SW LODI LN.

RS01-176144

To: Mike Adams, Pollard Houser
From: Ryan E. Paddock, CSA Consulting Engineers
Re: Portal Frame Check, PH Job#21-50R, SW Lodi Ln., CSA Job #3040.

PROJECT INFORMATION		Occ. Group	Const. Type
Single Family Dwelling	New Construction	R3	V-N
Project Description: REV- LATERAL ENG. (BP'S)--2 SETS ONLY--(NSFR- WINFIELD LOT 1)

Please refer to the following floor plan for clarification of the above noted locations.

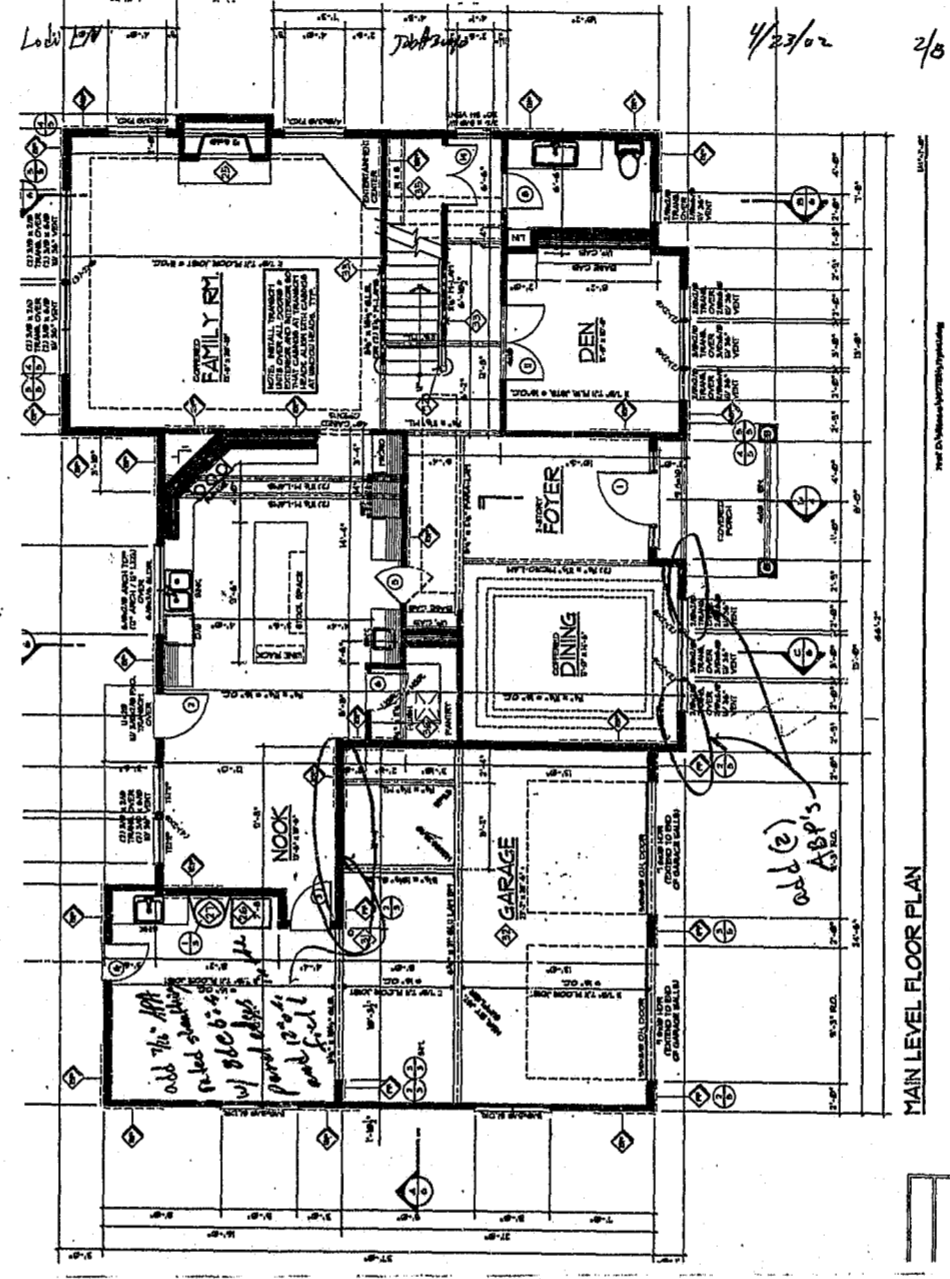
The portal frames at the back wall of the garage and at the garage front do not meet the height requirements as detailed on the construction documents. In order to provide lateral strength equivalent to the shear walls noted on the construction documents, we recommend adding shear walls in two areas as follows:

- 1) Sheath the 12.5' long back wall of the garage with 7/16" AFA rated panels with 8d @ 6" o.c. panel edges and 12" o.c. in the field. Panel edges shall be fully blocked and the space between joists above the wall shall be fully blocked.
- 2) Add (2) ABP's to the front dining room wall. Holdown anchors shall be retro-fit using ASTM A36 steel threaded rods with 10" minimum embedment into the existing concrete using Simpson SET epoxy adhesive or equivalent. Install per manufactures specifications.

PORTAL FRAME DETAIL

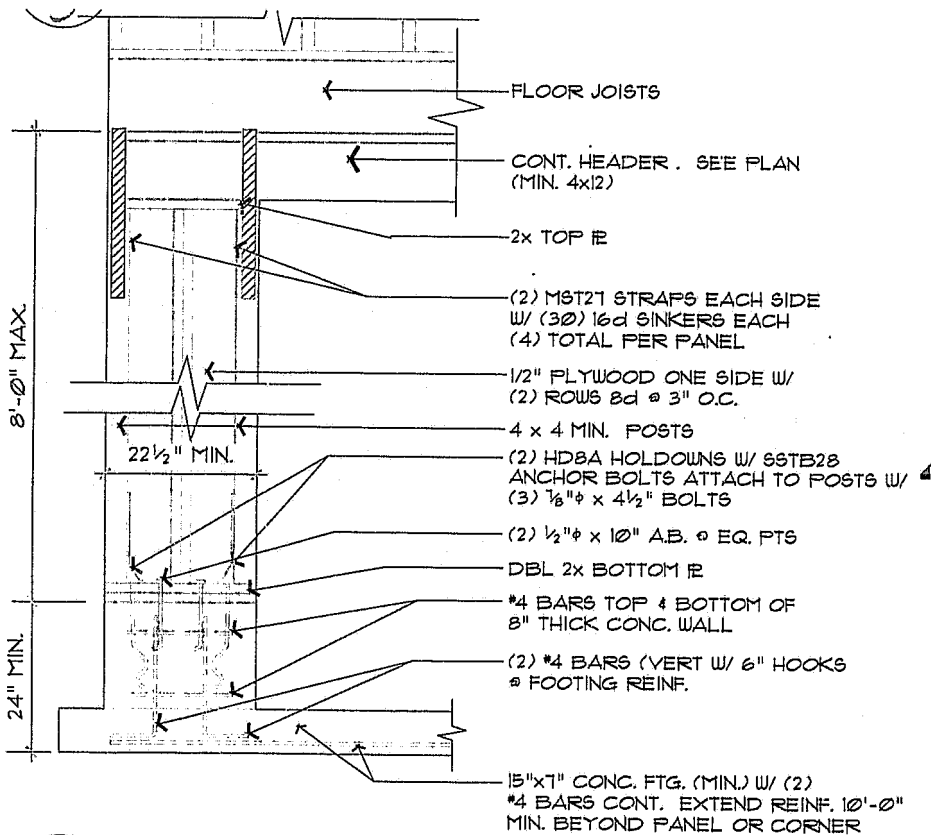
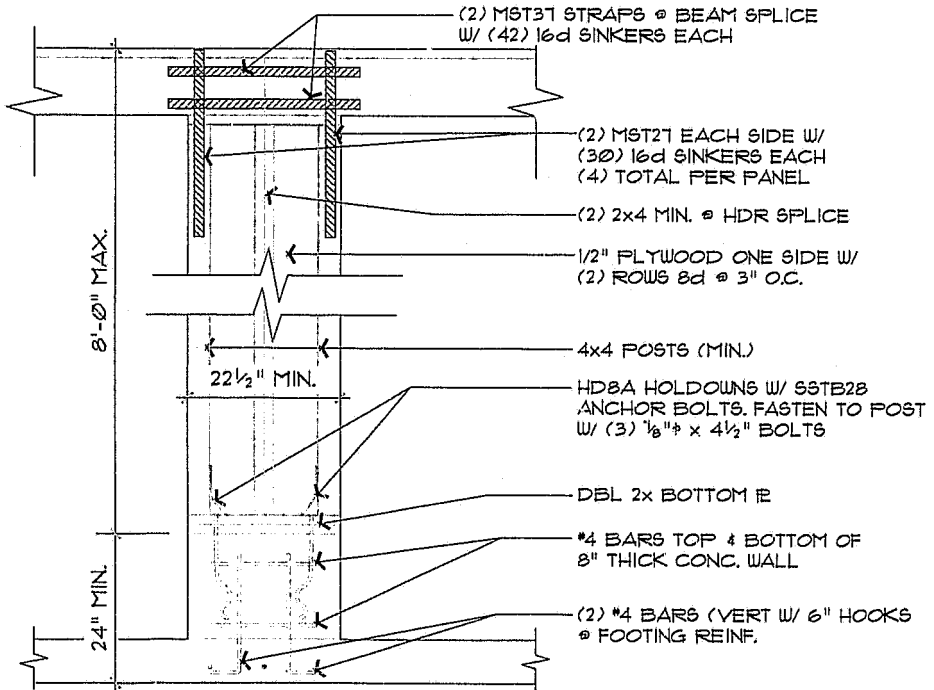
Max $h = 8'$ according to PF detail,Actual $h = 8'-9" \Rightarrow$ capacity willbe reduced by: $(1 - \frac{96"}{105"})(100) = 8.6\% \rightarrow$ assume it's reduced by 5% \Rightarrow Add shear walls to resist $.5 \times 3949 \text{ lbs} = 1975 \text{ lbs}$

$$V = 1975 / 2 (2.75') = 359 \text{ plf}$$

$$H0 \text{ req'd} \approx Vh = 359 (10') = 3580 \text{ lbs}$$

\rightarrow use (c) ABP's @ Dining Rm
